**ZONING AMENDMENT
& SUBDIVISION STAFF REPORT**

Date: March 6, 2008

911 Dauphin Street, Inc.

The Moors at Springhill Subdivision

SITE PLAN

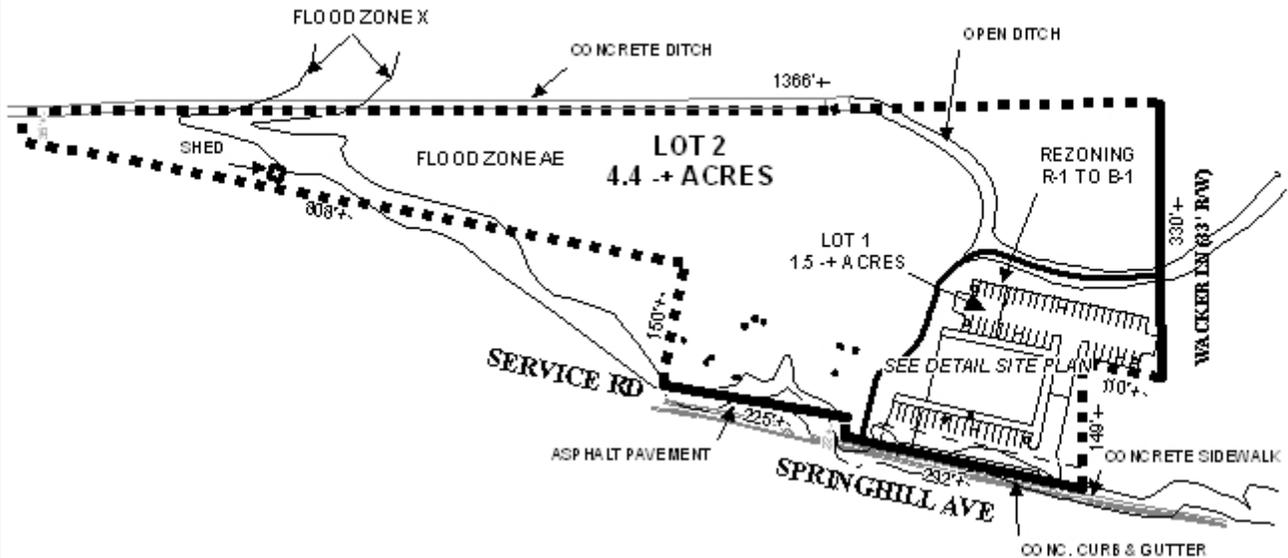
The plat should be revised to depict dedication of right-of-way along Wacker Lane sufficient to provide 25-feet, as measured from the centerline.

The 25-foot minimum building setback is not depicted for proposed Lot 2, but would be required on the final plat, if approved. The 25-foot setback should also be depicted from the frontage on Wacker Lane.

It should also be pointed out that there appears to be a discrepancy between the area claimed for the site under consideration and three properties fronting Spring Hill Avenue, which back up to the Western side of the site. It appears that the three properties include a portion of a site as part of their parcels. Information to resolve the issue should be provided, or the plat should be redesigned to exclude the area.

- 1) Provision of information to clarify apparent property ownership discrepancy on the Western side of the site, or revision of the plat to remove the areas from the site; and
- 2) Revision of the plat to depict all sanitary sewer, drainage and other easements, and the illustration that a viable site for commercial development remains that will not be a risk to public health and safety.

DETAIL SITE PLAN

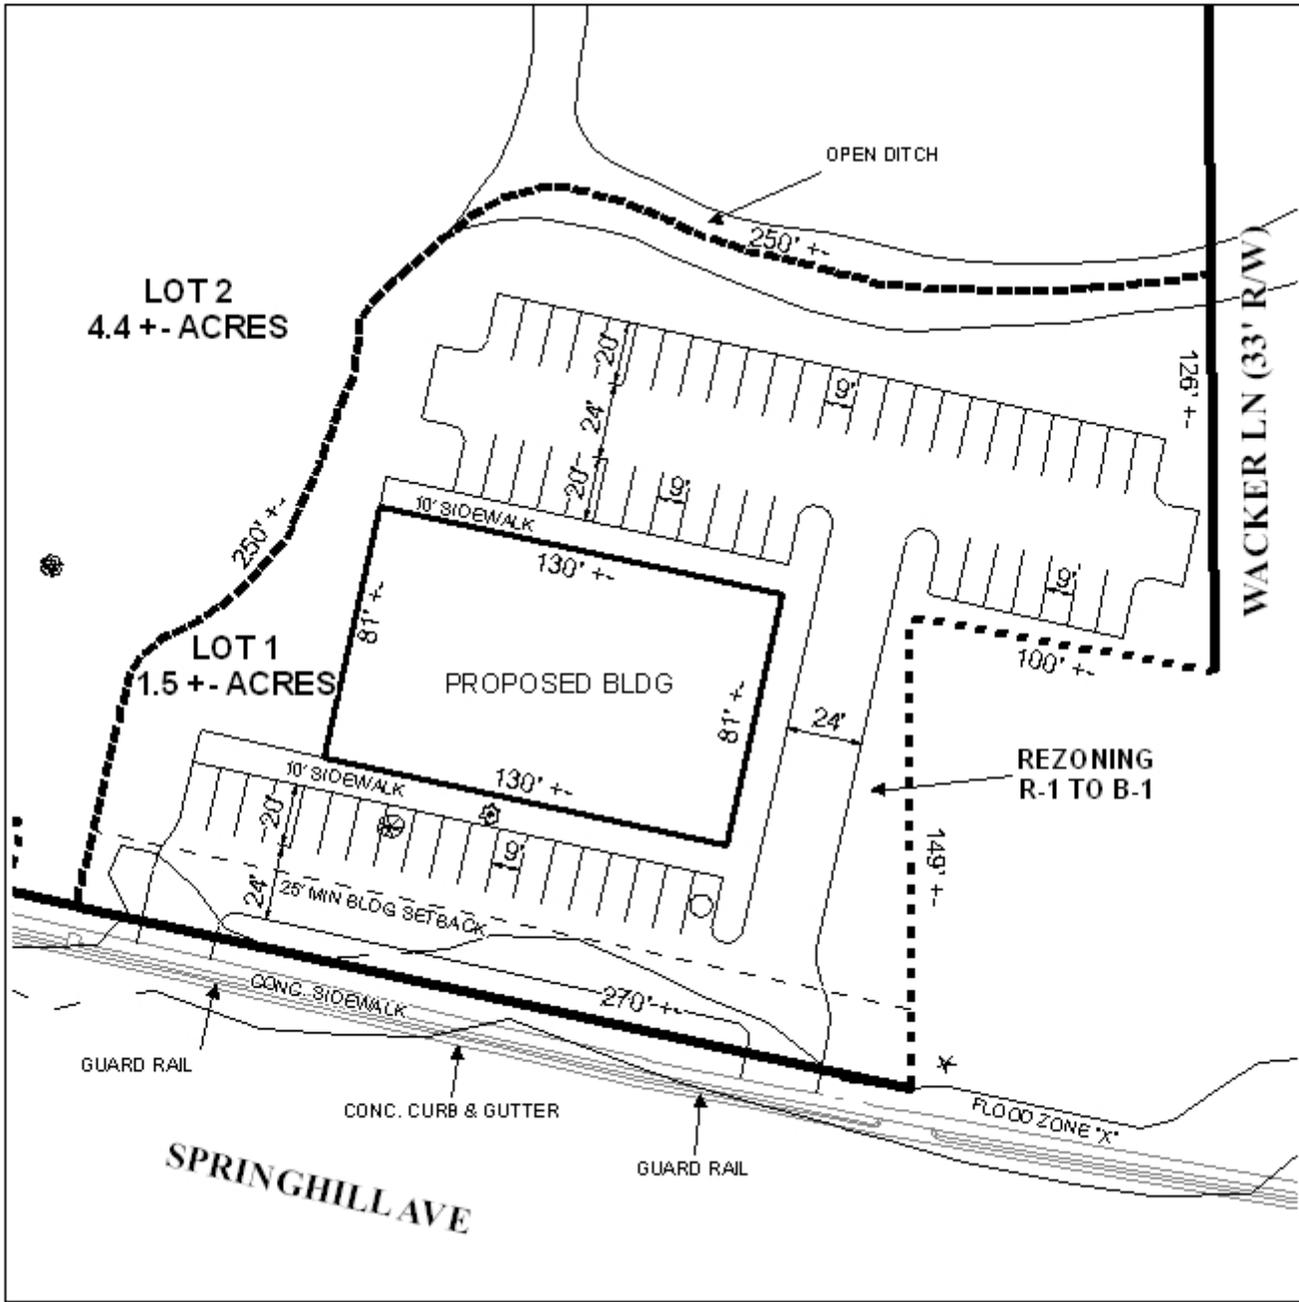
Spring Hill Avenue is a five-lane major street, with 22,000 cars per day on average (per 2006 data), and as such access management is a concern. The applicant is proposing two curb-cuts for proposed Lot 1, the lot that will be commercially zoned. Proposed Lot 2, for which no development is proposed at this time, essentially only has frontage on an existing service road. Due to the number of existing curb-cuts on the South side of Spring Hill Avenue, proposed Lot 1 should be limited to one (1) curb-cut, to align with the larger existing curb-cut across the street, and proposed Lot 2 should be limited to one (1) curb-cut onto the existing service road, with the size, design and exact location to be approved by Traffic Engineering and conform to AASHTO standards.
